SOLICITATION NO. SA 04300021**Management & Operation of the City of Austin's Type IV Landfill;
Permit No. 360A*****Date Issued: March 15, 2004******Closing Date and Time: May 20, 2004, by 3:00 PM*****Prepared by****Robert S. Kier Consulting*****October 26, 2004*****Background**

October 26, 2004

FIGURE 2-1
POTENTIOMETRIC MAP

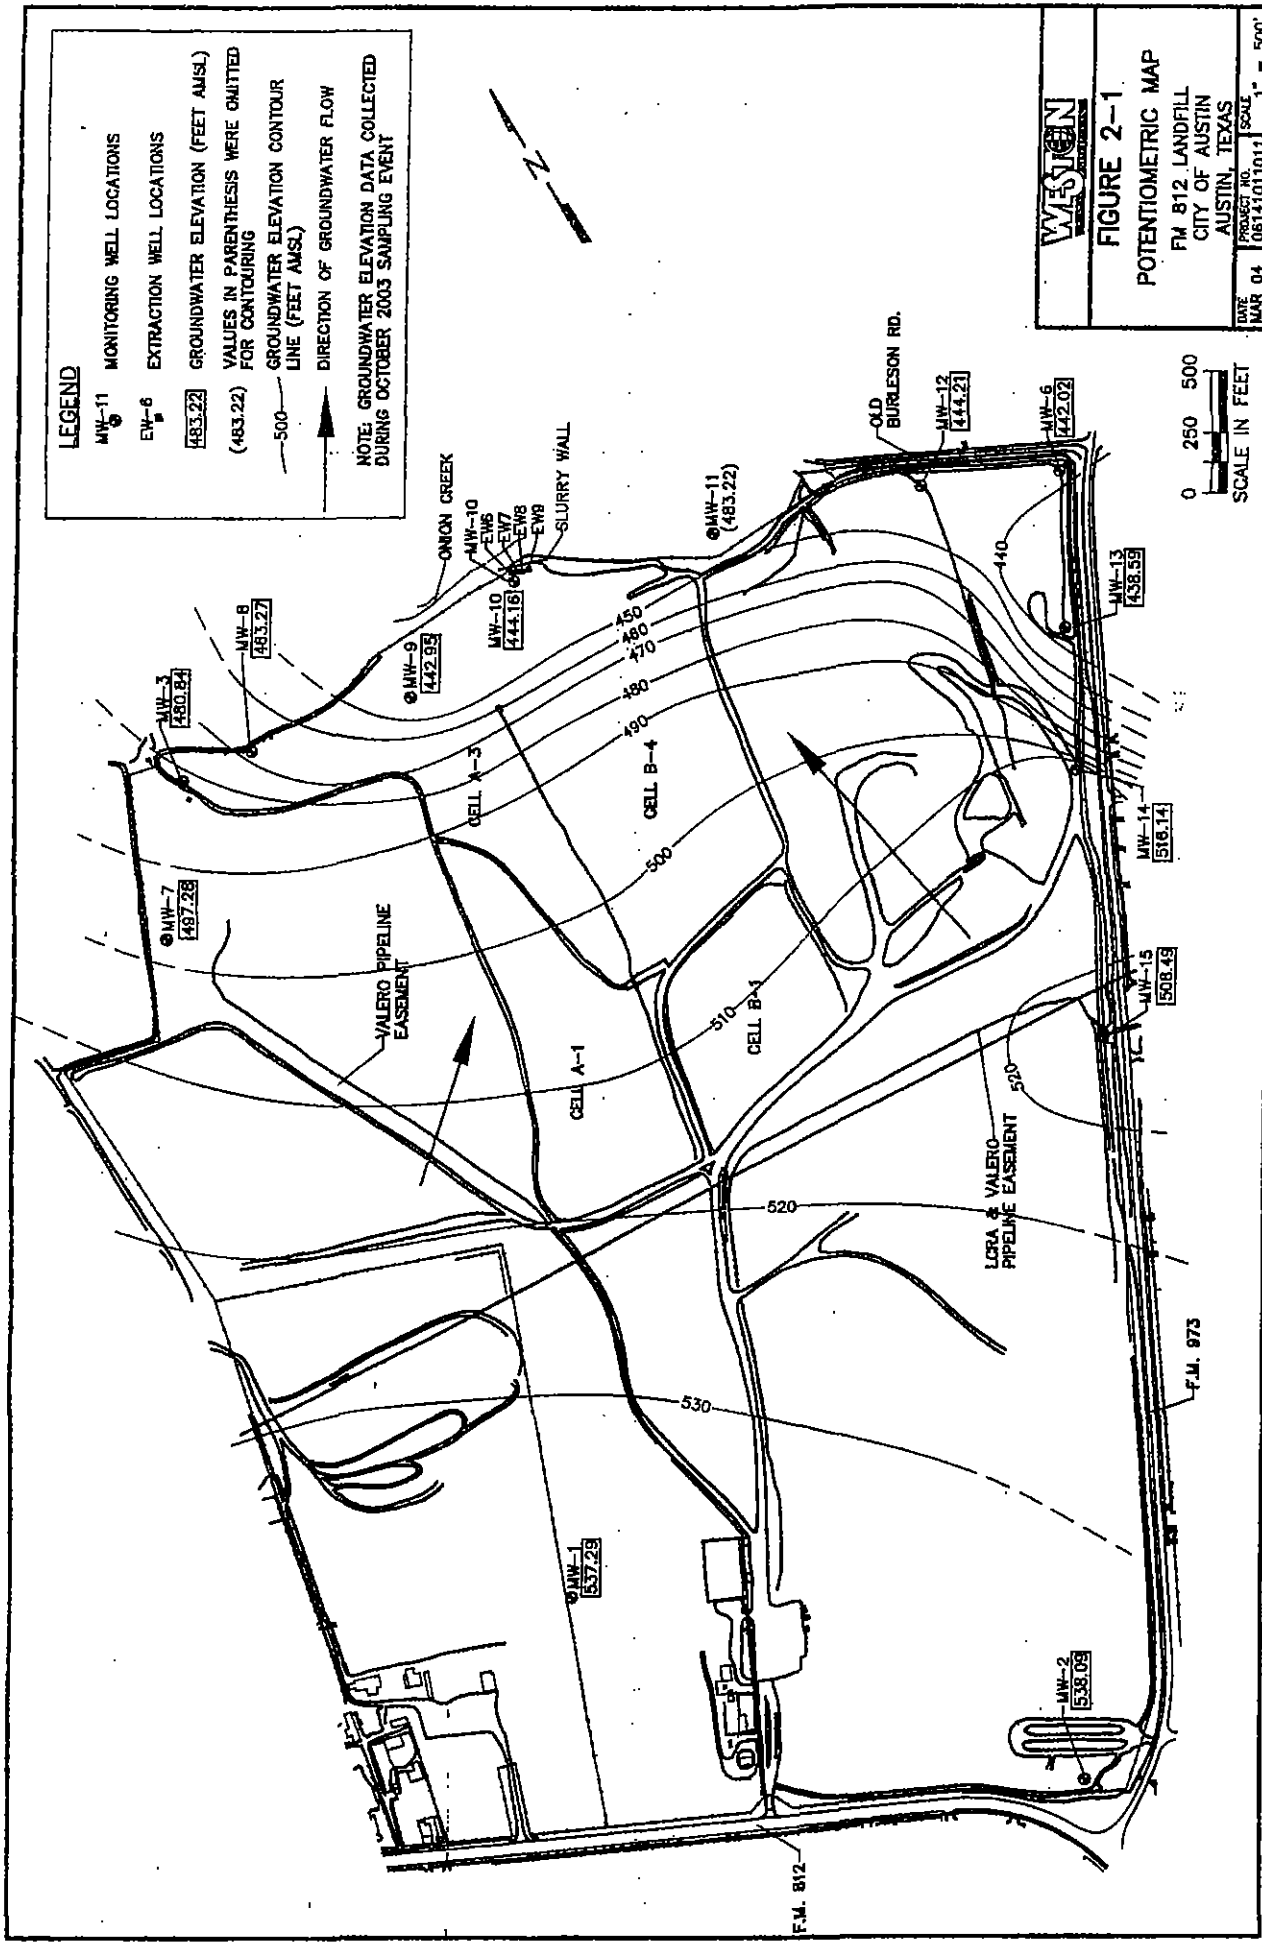
A slurry wall was constructed at the toe of the slope of Cell B-4 in 1994, approximately 24 ft north of Extraction Well, EW-6 (due north of MW-10). This slurry wall measures approximately 300 ft in total length, beginning approximately 45 ft northeast of EW-6 and extending to approximately 135 ft northwest of EW-9, as shown in Figure 2-1. The slurry wall is approximately 3 ft wide and completed at varying depths from 18 ft bgs to 24 ft bgs, where it is “keyed” into a shale to “anchor” the wall. The slurry wall is located approximately 150 ft downgradient (north) of the base of Cell B-4, and approximately 100 ft upgradient (south) of Onion Creek, as shown on Figure 2-1.

MW-10 is located at the toe of the slope of Cell B-4 upgradient of the slurry wall, as shown on Figure 2-1 and is completed to approximately 25 ft bgs. It is suspected that groundwater being monitored by MW-10 is intermingled with releases of leachate near the base of Cell B-4. The elevated nitrate concentrations reported in MW-10 are likely associated with this intermingling. Due to the absence of actively pumping extraction wells, it is likely that potentially leachate-affected groundwater is pooling behind the slurry wall. Because the existing slurry wall does not extend far beyond EW-6 and MW-10, it is believed that the potentially leachate-affected groundwater could be migrating around the edges of the slurry wall toward Onion Creek.

- Onion Creek is believed to be the general base-level for shallow groundwater at the FM 812 Landfill. The potentiometric surface of shallow groundwater present at the landfill is illustrated in Figure 2-1, which is based on groundwater level measurements collected during the October 2003 groundwater monitoring event. The potentiometric surface illustrates the south-to-north component of the gradient, toward Onion Creek. Groundwater present at the northern boundary of the landfill likely contributes recharge to Onion Creek (COA, 2003).
